Consists of information furnished in response to NRC staff questions concerning applicant's Appendix I submitted on June 4, 1976 re the Turbine Building Exhaust System..... with attached drawings.....

PLANT NAME: Oconee 1-2-3

Re: Oconee Nuclear Station  
Docket Nos. 50-269,-270,-287

RESPONSE TO REQUEST FOR ADDITIONAL INFORMATION ON 10CFR50 APPENDIX I

KEY PLAN  
(BASED ON 7/25/77)  
SCALE: 1/8" = 1'-0"

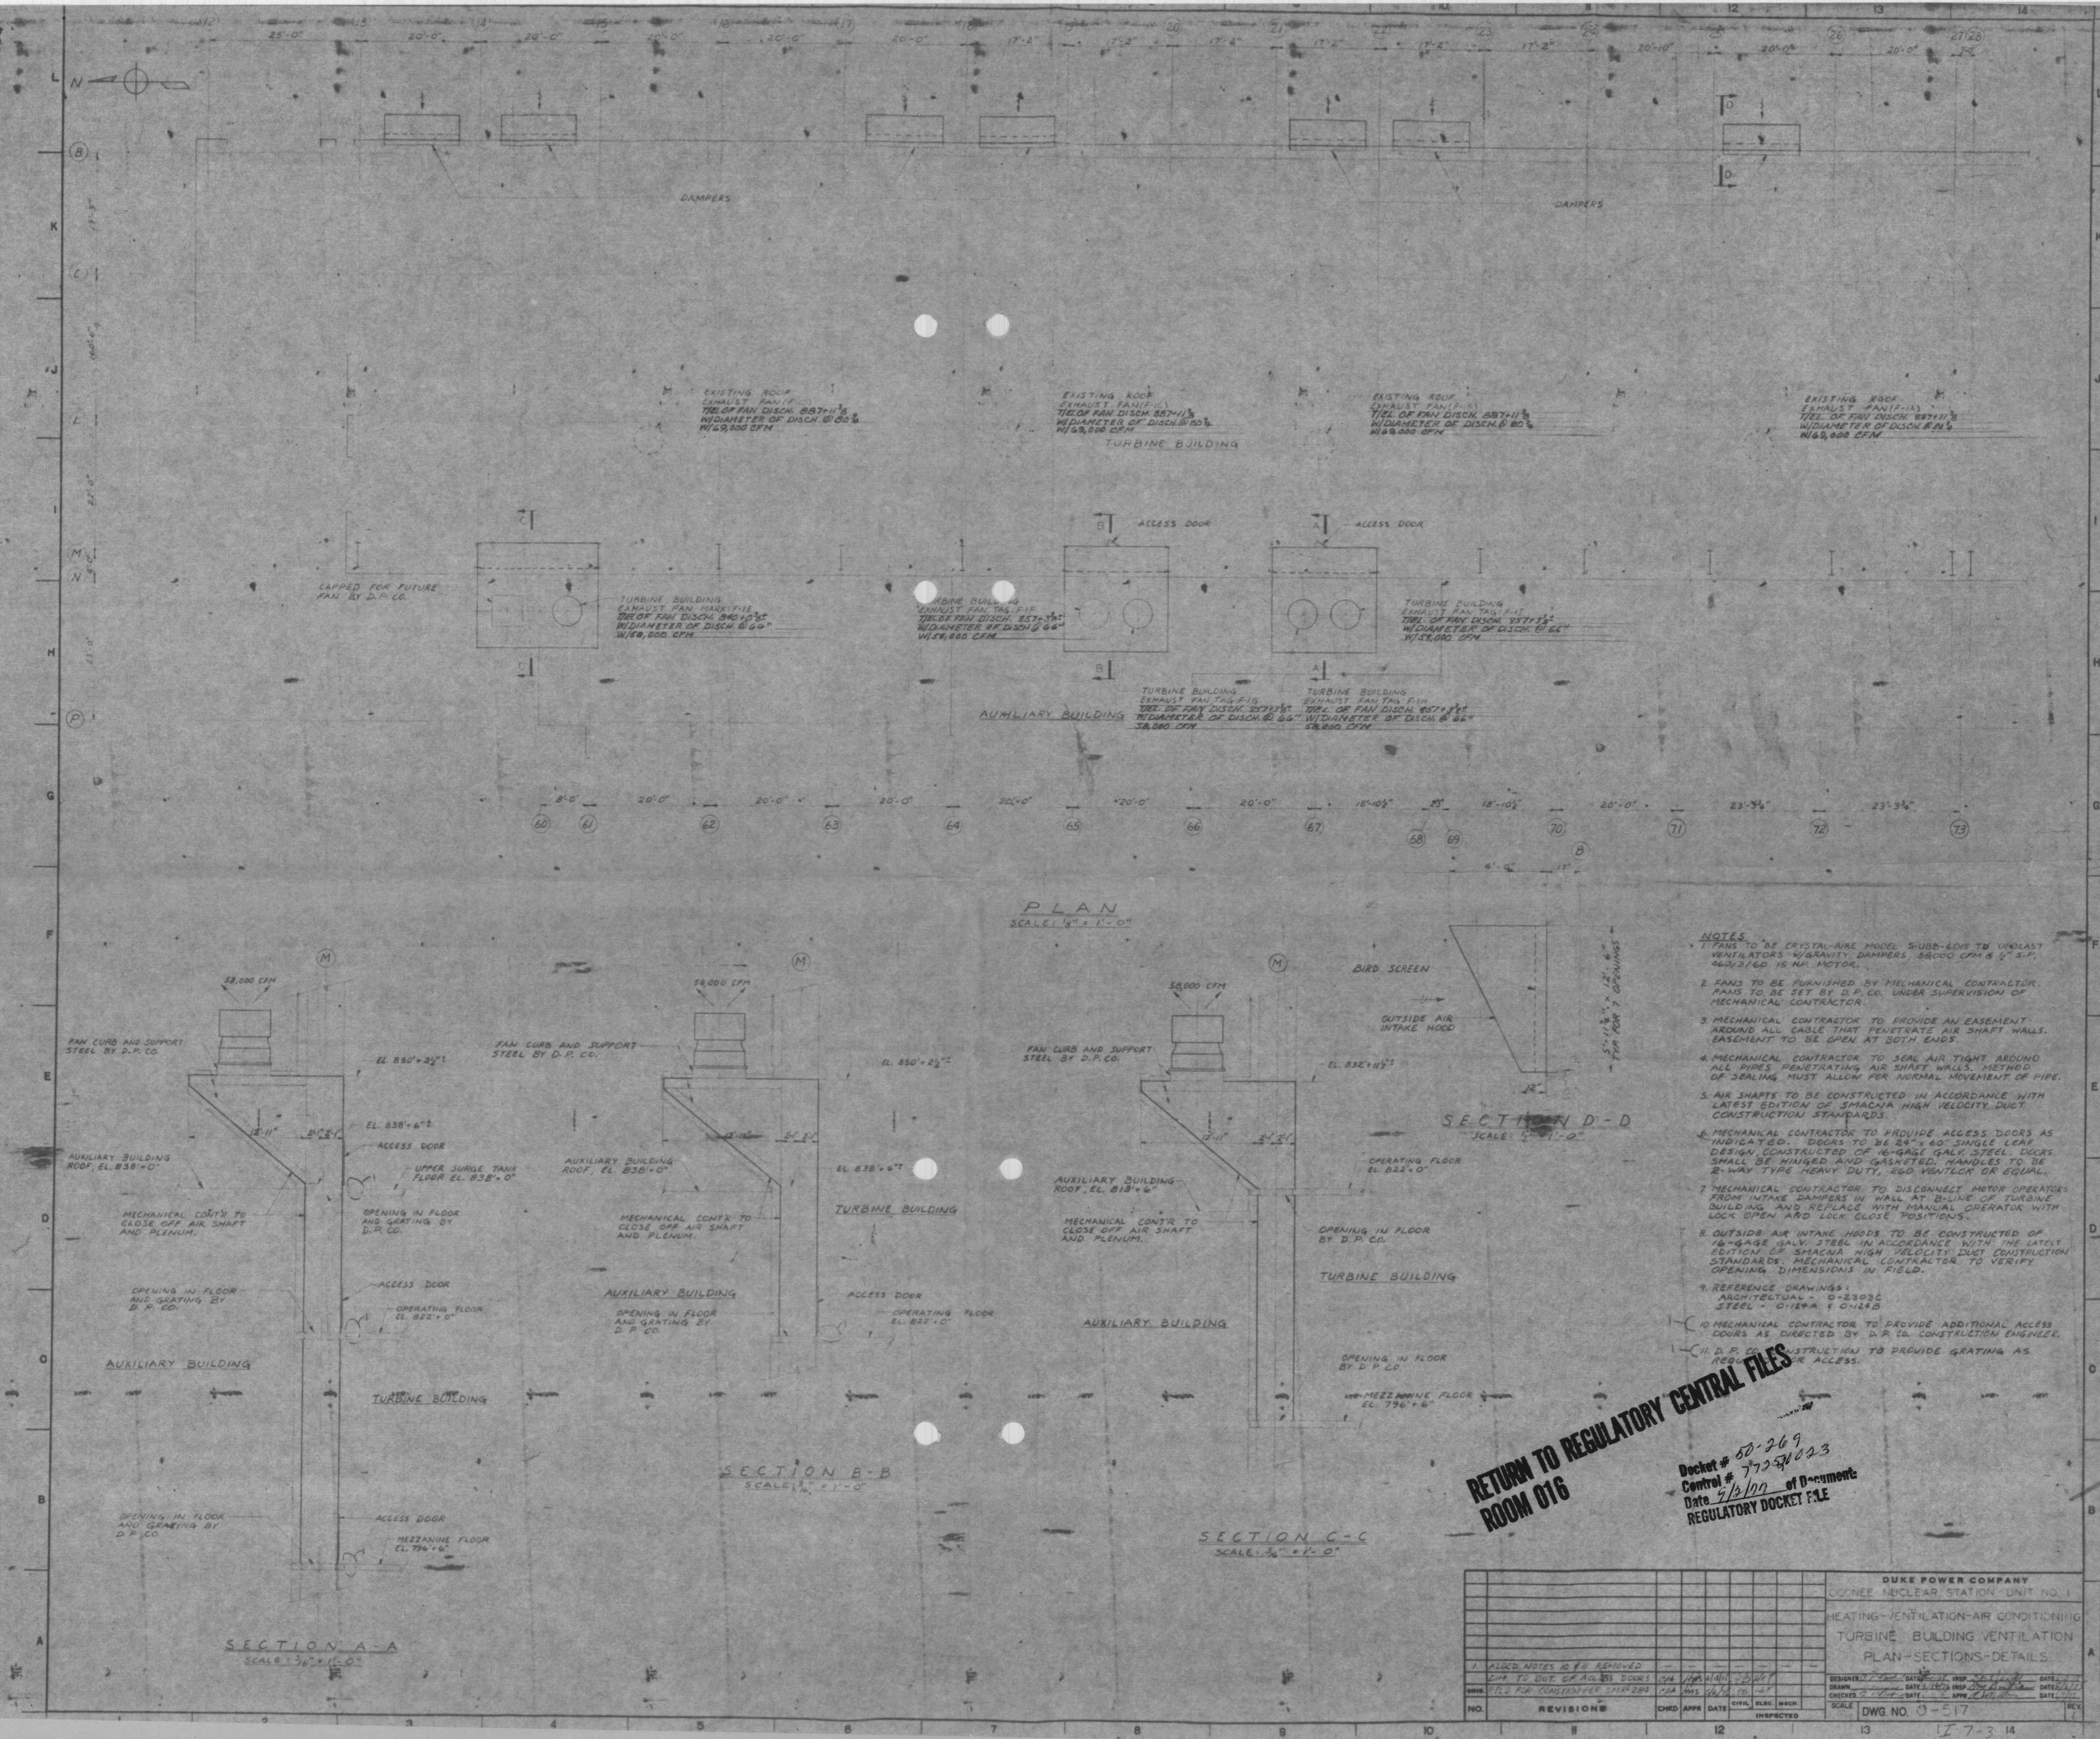
1. Question - Provide the description of the Turbine Building Exhaust System, including flow rate, velocity, height above grade, height above and relative location to adjacent structures, relative temperature difference between exhaust effluent and ambient air, and size and shape of the flow orifice.

Response - Details of the Turbine Building Exhaust System fans for each unit are as follows:

Note: All fans are arranged "in-line," running North - South. All locations given are from the center of this line; i. e., center of Turbine Building, Unit 1, North - South dimension. See attached drawings for additional details.

6. Height above and location relative to adjacent structures (all fans):  
Note: All fans are arranged "in-line," running north - south. All locations given are from the center of this line; i.e., center of Turbine Building, Unit 2, North-South dimension. See attached drawing for additional details.

5. Size and Shape of Flow Orifice:
  - a) Fans 3A through 3D - 80 3/4" diameter, round.
  - b) Fans 3E through 3J - 66" diameter, round.
6. Height above and location relative to adjacent structures (all fans):  
Note: All fans are arranged "in-line," running North-South. All locations given are from the center of this line; i.e., center of Turbine Building, Unit 3, North-South dimension. See attached drawing for additional details.
